East Anglia TWO Offshore Windfarm

Outline Access Management Plan

Applicant: East Anglia TWO Limited Document Reference: 8.10 (Tracked)

ROAD SAFETY AUDIT – DESIGNER'S RESPONSE

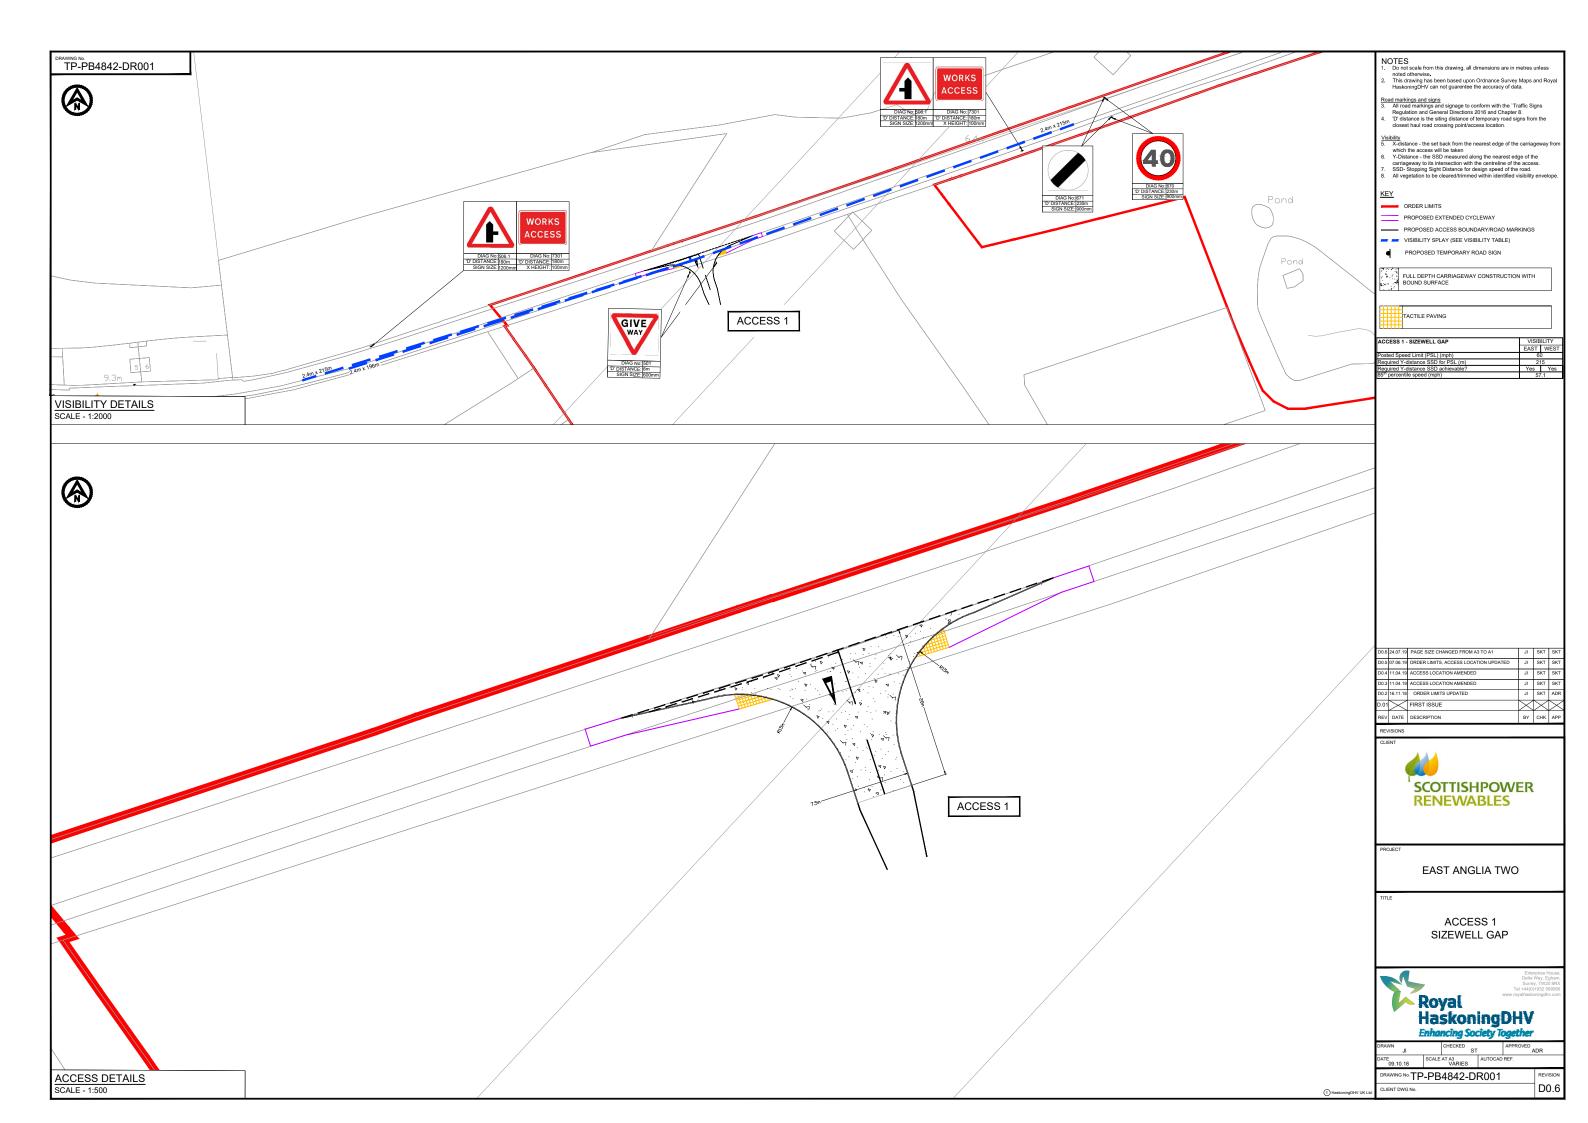
B1.2.1 Problem 2

Location: Access 1 from Sizewell Gap road.

Summary: Accelerated wear of the carriageway could result in premature highway failure leading to the potential for potholes to form which could destabilise cyclists and motorcyclist leading to personal injury.

Description: The Audit Team observed cracking of the existing highway in the vicinity of Access 1. The addition of turning HGV traffic at this location could lead to an acceleration of the wear of the carriageway surface and the potential for the carriageway to 'pick out' and potholes to form. If cyclists or motorcyclists were to collide with these potholes the rider could be destabilised, potentially leading to a fall and personal injury.

Resurface/ repair the carriageway opposite Access 1 to prevent premature failure of the carriageway.

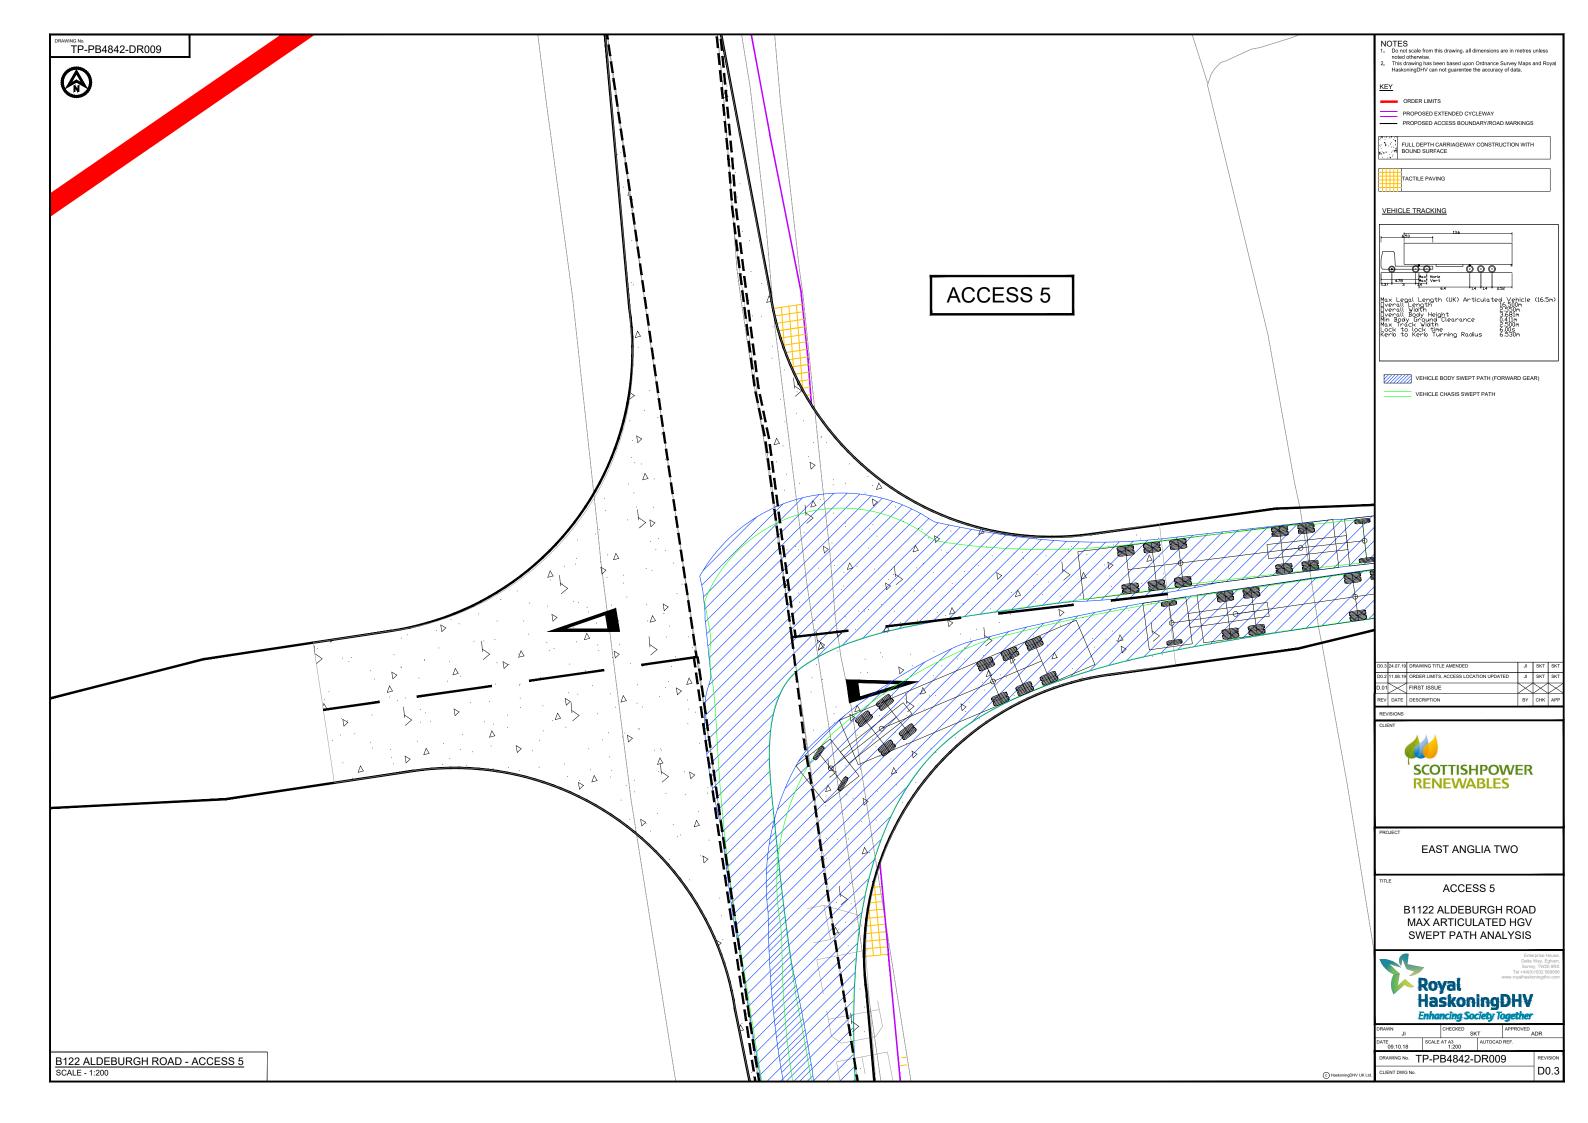
B1.1.1 Problem 1

Location: Access 5 from the B1122 Aldeburgh Road.

Summary: Stationary buses could restrict forward visibility of oncoming vehicles for drivers egressing from Access 5, leading to the potential for collisions.

Description: An existing bus stop is located to the south of the existing access to Aldringham Court. When a bus is stationary at the bus stop the forward visibility of vehicles from the north (travelling south) from Access 5 would be restricted by the stationary bus. Reduced visibility, due to the stationary bus could lead to vehicles pulling out of Access 5 into the path of an oncoming vehicle, potentially leading to side impact collisions.

Relocate the existing bus stop to ensure it is located outside of the proposed visibility splay.
